TRANS/WP.29/GRRF/2002/17/Rev.1
22 November 2002

PROPOSAL FOR DRAFT AMENDMENT TO REGULATION No. 64

(Temporary use spare wheels/tyres)

Transmitted by the Expert from the United Kingdom

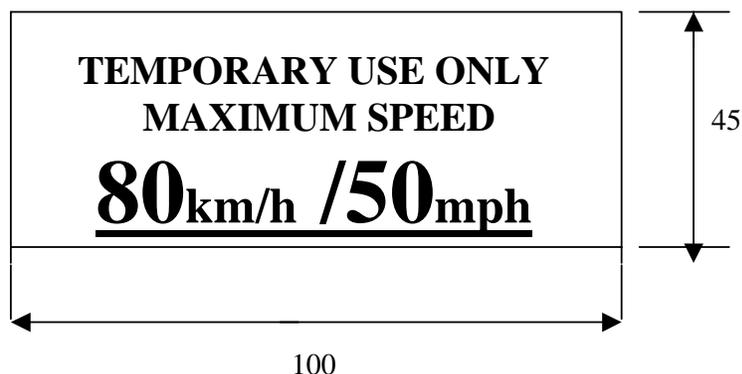
"5.1.4.1. An 80 km/h maximum speed warning symbol arranged in accordance with the diagram below, shall be permanently displayed on the outer face of the wheel in a prominent position.

In the case of vehicles intended to be sold in countries using imperial units of measurement, an additional warning symbol, identical to that described above, with the exception that the figure "80" shall be replaced by "50" and the wording "km/h" by "mph", shall be permanently displayed on the outer face of the wheel in a prominent position.

Alternatively a single warning symbol arranged in accordance with the diagram below, shall be permanently displayed on the outer face of the wheel in a prominent position.

Upper case letters shall be at least 5 mm high and the numbers “80” and “50” shall be at least 20 mm high with the elements that make up each character of the number at least 3 mm line thickness. Lower case text shall be at least have a line height of 5 mm. All text shall be enclosed in a border and be on a background of contrasting colour.

The requirements of this paragraph shall not apply to a temporary use spare wheel and tyre unit that includes or comprises either a run-flat system tyre or a uni-directional tyre."
